Subject: Meeting Notes; Instrumentation and Controls Systems Branch (ICSB)

SEABROOK STATION
ATTENDANCE ROSTER-ICSB MEETING
AT
UNITED ENGINEERS & CONSTRUCTORS

FIGURE 1

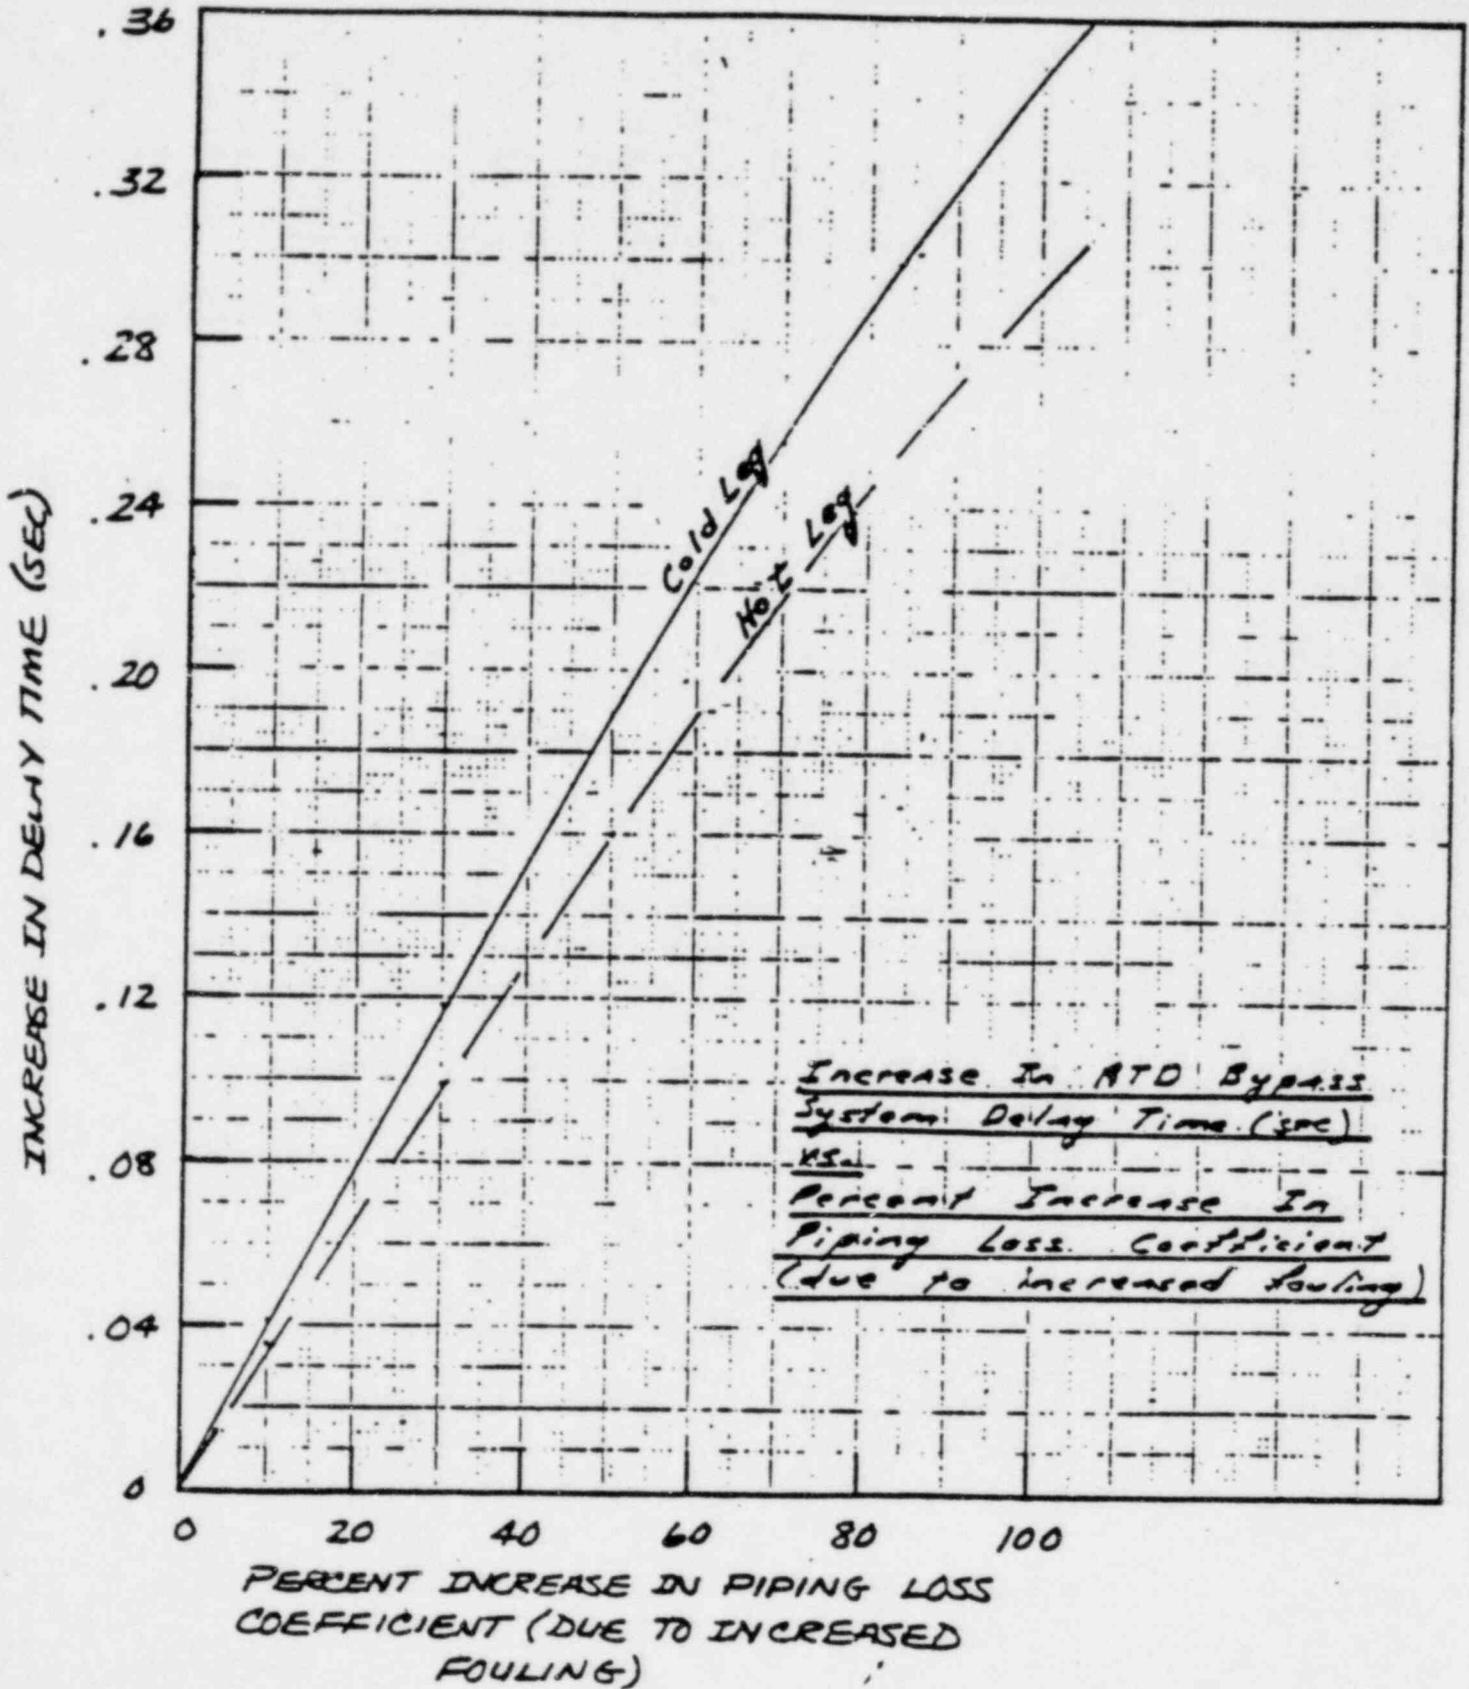
In part 2 of the evaluation a parametric study was performed to determine the effect of increased fouling on the delay times. Figure 1 is a plot of the increase in the hot and cold leg transport delay time as a function of the percent increase in piping loss coefficient (due to fouling). Loop 1 was used as a representative loop to generate this plot but we can expect Loops 2, 3, and 4 to behave similarly. Summarizing this part of the study, the hot leg loss coefficients would have to increase by the amounts listed below before the 1.0 second maximum delay time would be reached.
